TECHNICAL MEMORANDUM

DATE: July 27, 2015

SUBJECT: Conceptual Design for Sonoita Creek, AZ, Technical Review Support (Order Number EP-G149-00241)

Figure 2a. Hydrologic soil group map and color-coded ratings for Sonoita Creek area (see next page for map legend).

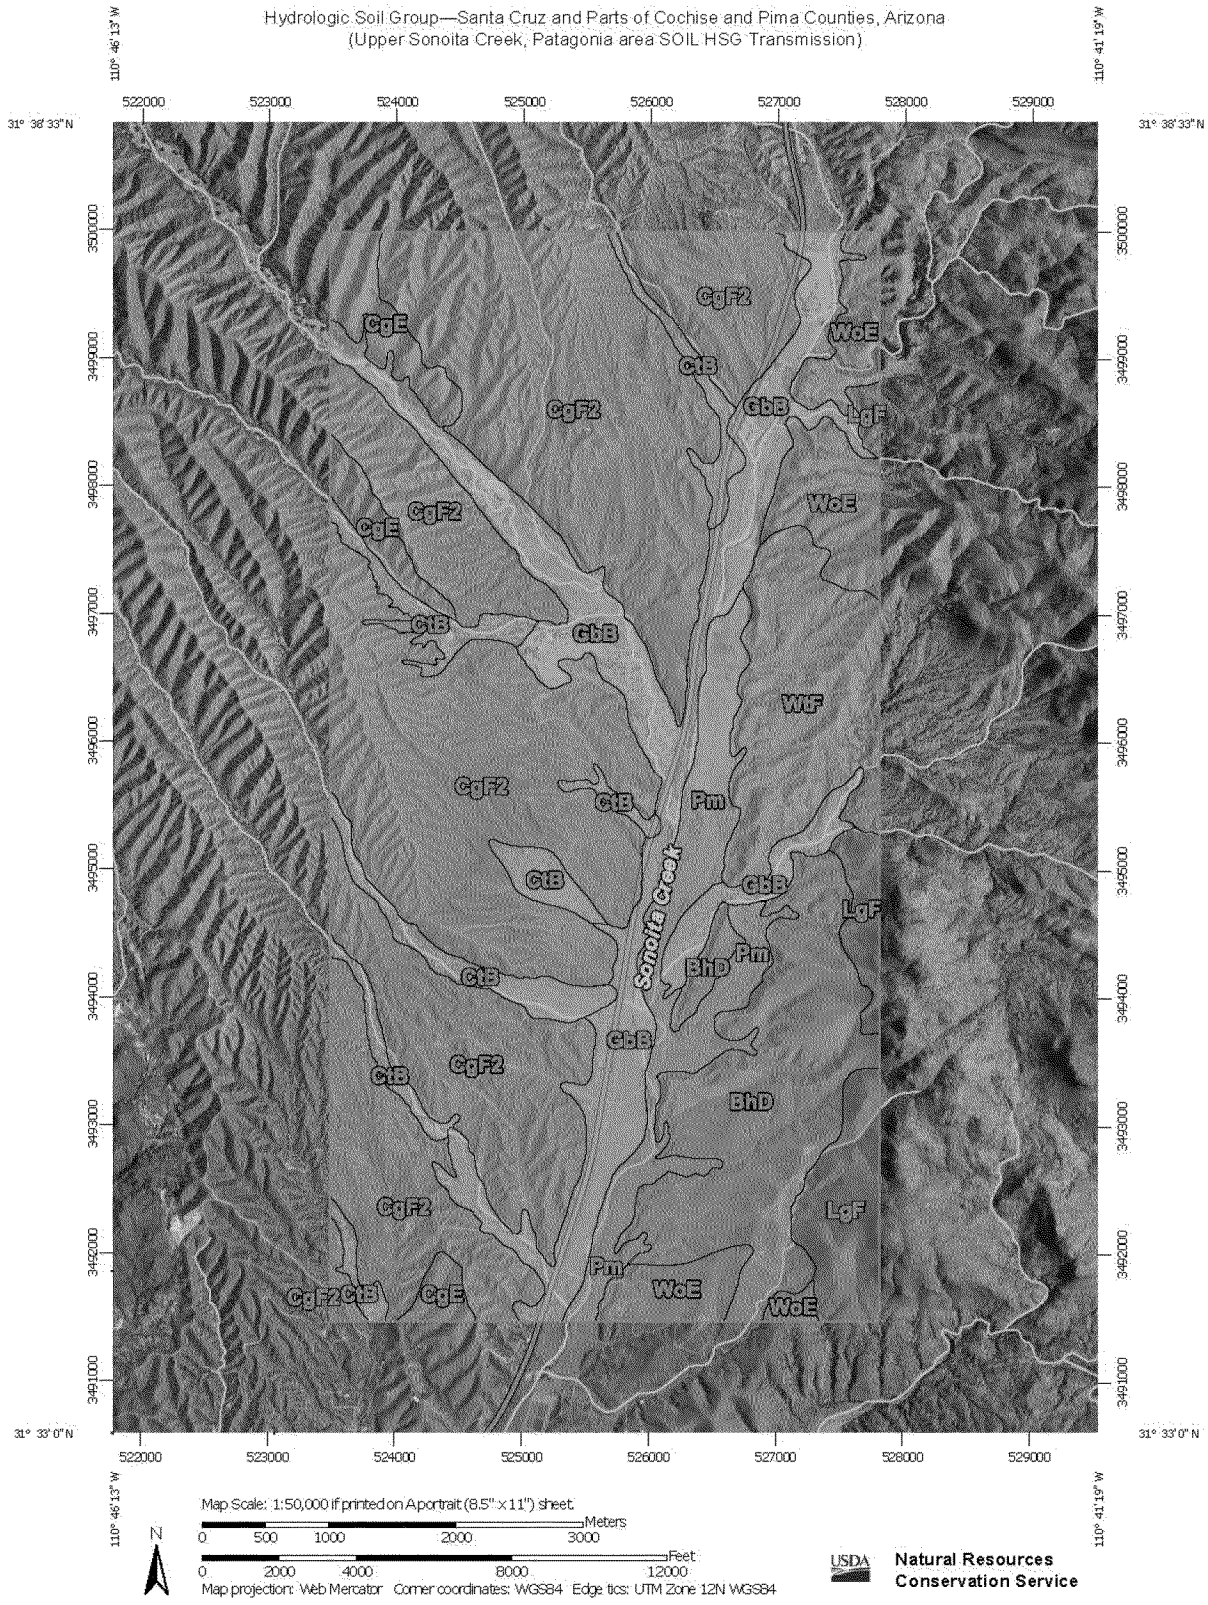
3) **The proposed constructed channels will likely not sustain flow in the specific soil types within the project reach.** The Sonoita Creek valley bottom consists primarily of alluvial deposits. In terms of mapped soil units, it is dominated by Grabe-Comoro complex (GbB) soils of gravelly sandy loam to sandy loam composition, that receive a hydrologic soil group classification (HSG) of Group A (refer to Figure 2a and 2b). Group A soils are characterized by high infiltration rates, low runoff potential, and a high rate of water transmission. The Sonoita Creek floodplain also has a lesser percentage of Pima soils (Pm), a clay loam that receives a HSG classification of Group C. Group C soils are characterized by slow infiltration rates and slow water transmission.

Transmission losses due to infiltration into the bed and banks are high in semiarid ephemeral streams, and multiple researchers have demonstrated that except during the highest flows, there is significant loss of in-stream flow due to seepage as the flow proceeds downstream in alluvial valleys (Levick, et al. 2008). The WET report (p.12) notes that transmission losses for streams like Sonoita Creek have been reported as high as 17-29%. Approximately half of the constructed pilot channels as proposed in the plan would be excavated into the highly permeable Grabe-Comoro complex soils, resulting in high transmission losses. Any portion of the flow that entered the newly constructed channels during low to moderate flow rate events, such as those that occur at a high frequency annual scale, would likely not be sustained, and likely not return to the main Sonoita Creek channel. Sediment drops out of suspension as infiltration occurs and flow drops in velocity, depositing new material in the channel. Resulting aggradation may fill the newly constructed channels, further restricting the ability of flows to be diverted and for any diverted flow to successfully return to the main Sonoita Creek channel, particularly at the downstream reaches of constructed channels. Continued aggradation in the constructed channel could eventually create an abandoned, non-functional channel. The overall result would be a loss of habitat in the main channel of Sonoita Creek and a failure to create new habitat in the constructed channels, therefore failing to meet the stated goals of the proposed design in the WET report.
